Access Compliance Report Public Rights-of-Way (Curb Ramps)

Main Street: N/A Cross Street: AIROSO_ST Location: SE

ADA ID: RPAT220126110448 Ramp Type: Type 6 - Directional 1 Initial Pass/Fail: Pass Overall Compliance: No Severity Score: 10

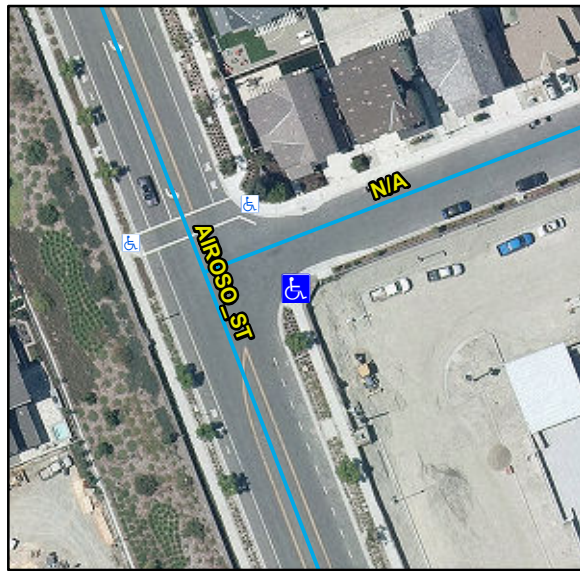
R304.2.2, R304.2.1, R304.2.2-Perp, R304.3.2-Para, R304.5.3, STD 1115

Marked Crosswalk 1 Width (in)	132			
Yes	Ramp Inside Crosswalk 1	Yes			
	Crossing 1 Slope (%)	0.1			
	Crossing 1 Cross Slope (%)	1			
Yes	Gutter Ponding	No	No	Curb Slope	14.5
Yes	Gutter Lip Height (in)	0		Road Run Slope (%)	N/A
Yes	Gutter Run Slope (%)	0.9		Road Cross Slope (%)	N/A
No	Gutter Cross Slope (%)	6.7		Parallel Ramp Side	Left
Yes	Overall Surface Condition	Acceptable	Yes	Perp Joint Present	Yes
	Cross Gutter Present?	No		Spandrel Present?	No
	Replace Cross Gutter?	N/A		Replace Spandrel?	N/A

Remove & Replace Entire Ramp. Remove & Replace Gutter.
